Discussion document

Review Commission Regulation (EU) No. 327/2011 (fans)

21 Nov. 2014

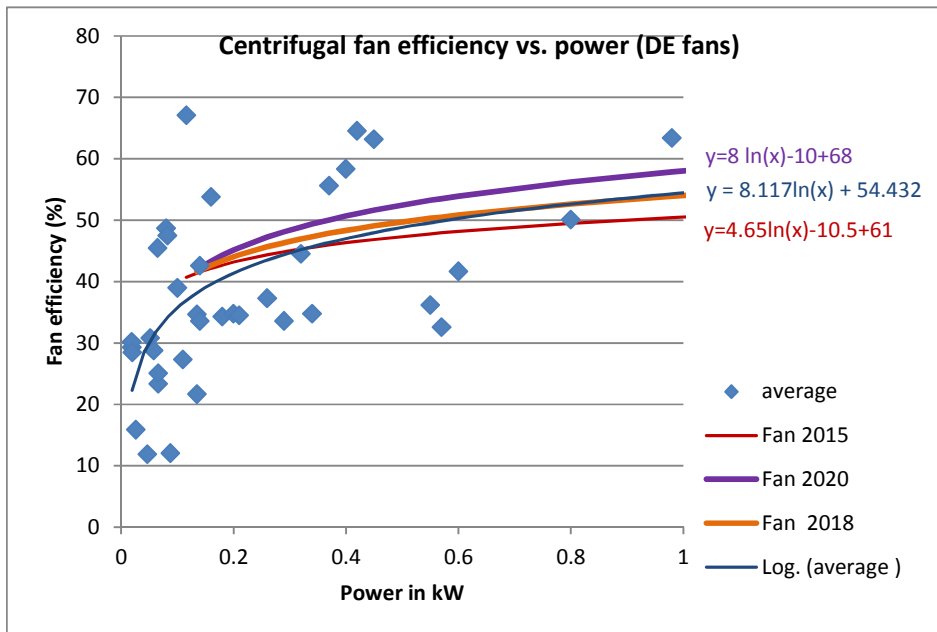
- Centrifugal fans: We propose one minimum efficiency for all. This would be a) following the stipulations of the review clause (reduce fan categories), b) methodologically correct (technology-neutral) and c) technically plausible. Radial blades are good for anti-clogging with high solid particle content (already excluded in Art. 1) or when they have to be reversible without a variable pitch (already included in the 10% bonus for dual purpose fans). Forward curved (FC) fans are a low-cost, low-efficiency alternative, but offer no unique qualities that cannot be reached with a backwards curved (BC) fan. Making separate, less stringent requirements for FC fans versus BC fans would not create a level playing field and would seriously hamper attempts to reach higher energy efficiency in important markets.

The following graphs give the relevant comparisons for the new centrifugal fan formulas.

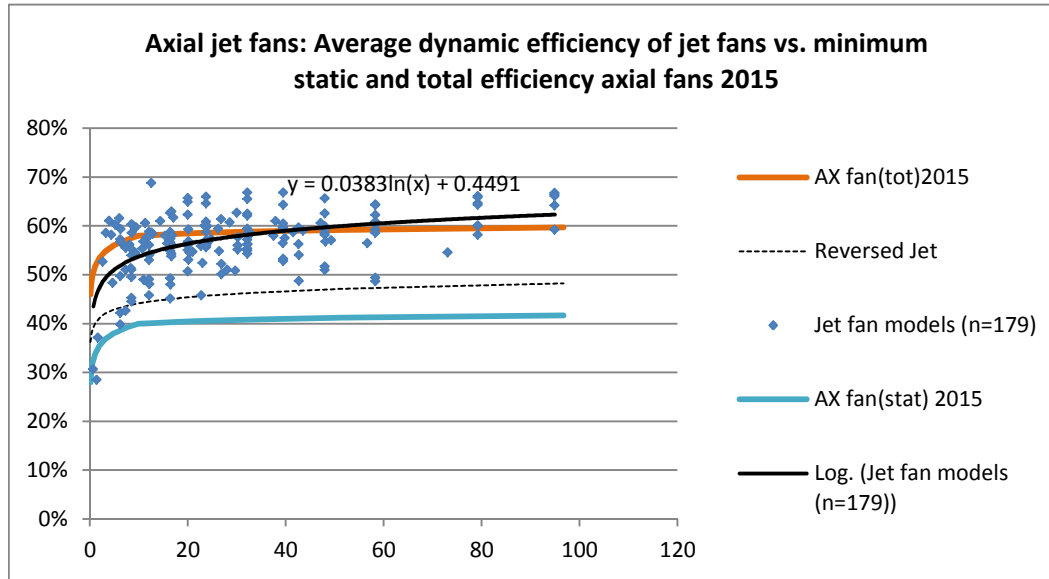
The dotted line is the trend line of the jet fans when they run in reverse, which only happens in case of emergency (i.e. fire), and can be ignored. Note that all jet fans in the database can have this dual purpose feature and thus could claim a 10% (factor 0.9) discount on the minimum efficiency curve.
